# UNITED STATES PATENT AND TRADEMARK OFFICE

APPLICATION NO.	FILING DATE	FIRST NAMED INVENTOR	ATTORNEY DOCKET NO.	CONFIRMATION NO.
10/528,010	11/16/2005	Karl-Heinz Danger	37546	8903
116 7590 06/19/2007 PEARNE & GORDON LLP 1801 EAST 9TH STREET SUITE 1200 CLEVELAND, OH 44114-3108			EXAMINER LEWIS, RALPH A	
			ART UNIT 3732	PAPER NUMBER
			MAIL DATE 06/19/2007	DELIVERY MODE PAPER

## Office Action Summary

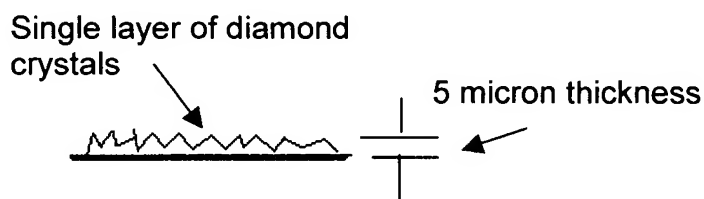
In response to the present rejection, applicant argues that the diamond single crystal particle layer of '102 while disclosed as having a thickness of 5 to 50 microns "has no relevance to ... the surface roughness" as is limited by the present claims. The examiner disagrees and is of the firm position that a single 5 micron layer of diamond crystals deposited on a surface would inherently have a roughness ranging from nearly zero (i.e. .5 microns) to 5 microns as is illustrated below.
